HARTZELL PROPELLER INC.
SERVICE BULLETIN
TRANSMITTAL SHEET
HC-SB-61-304

Propeller - Introduction of an Improved Blade

August 1, 2012

This page transmits a revision to Service Bulletin HC-SB-61-304.

Figure 1

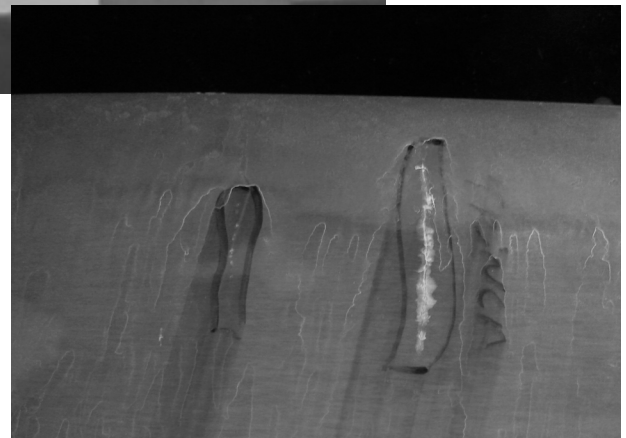
- (1) There have been sporadic reports of blade flutter during landing while using propeller reversing. An investigation identified a greater likelihood for this occurrence with blades nearing dimensional minimums.
 - (a) This same occurrence of blade flutter is also possible with blades near original manufacturing specifications.
 - (b) This condition can cause cracked and/or failed blades. Refer to Figure 1.

Cracks are located between the markings on the blades shown.

- (2) Blade Flutter can be identified by a large increase in sound level during application of reverse.
- (3) Blade replacement in accordance with the Compliance section of this Service Bulletin will minimize the tendency for flutter.
- (4) Replacement of all T10173F(N)(B,K)-12.5 blades with improved T10173AN(B,K)-12.5 blades is terminating action for this Service Bulletin.
- (5) Regulatory action is unknown.

Blade Butt Showing Damage to Prevent Further Use of the Blade
Figure 2

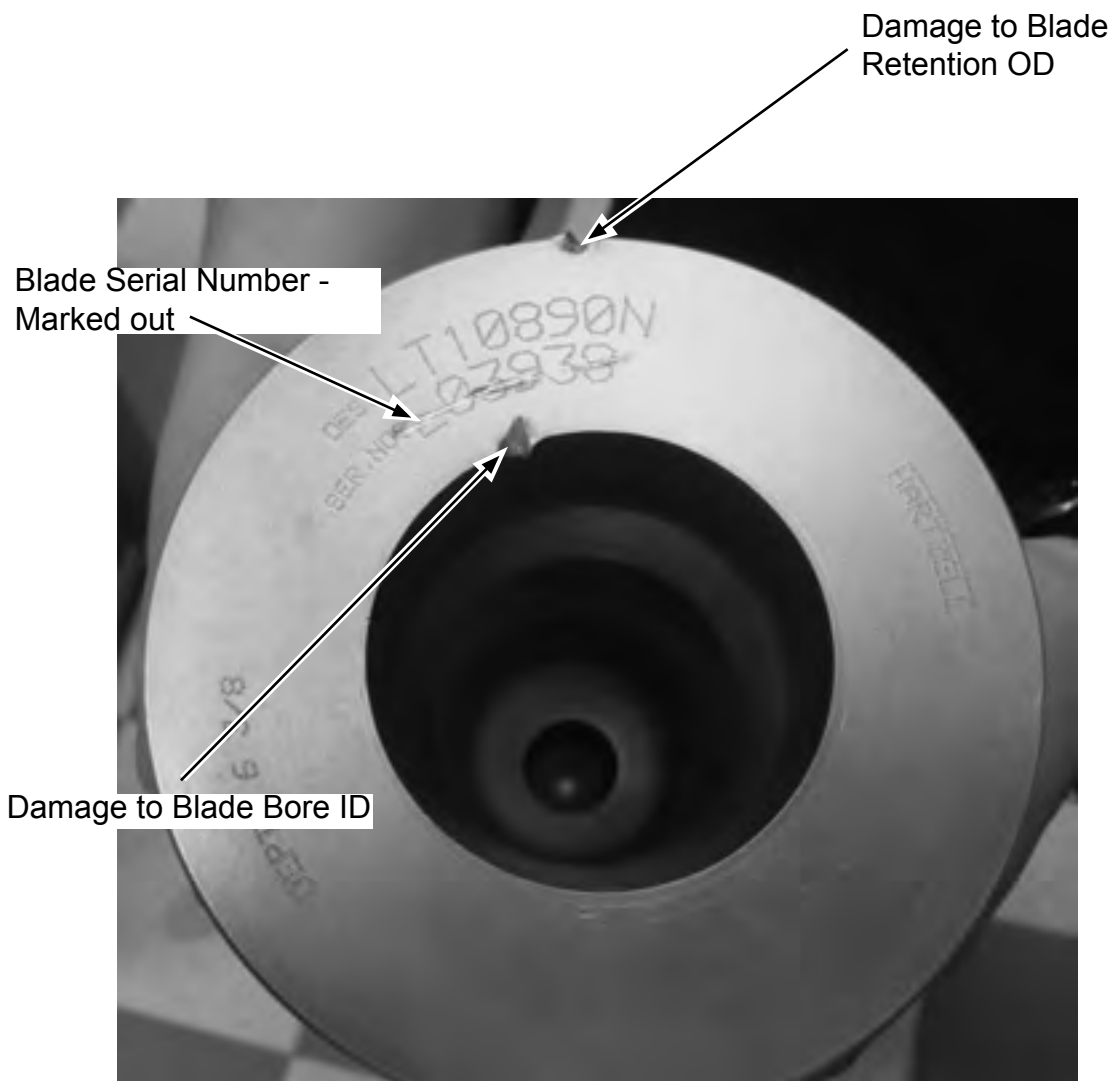
- 1 The retired blades cannot be modified or returned to service for use in any application, including experimental applications.
- 2 Each blade must be damaged in such a way that prevents further use of the blade.
 - 1 Using a tool, damage the ID of the blade bore and the OD of the blade retention surface. Damage must be sufficient to prevent installation of the blade bearing and the blade clamp. Refer to Figure 2.
 - 2 Mark out the blade serial number, so that the number is still legible.
 - 3 Take a photograph of the blade butt to show the damage, the blade model number, and the blade serial number. Refer to Figure 2.
 - 4 Send the photo via email to techsupport@hartzellprop.com in accordance with the Appendix to this Service Bulletin. **DO NOT RETURN THE BLADE.**
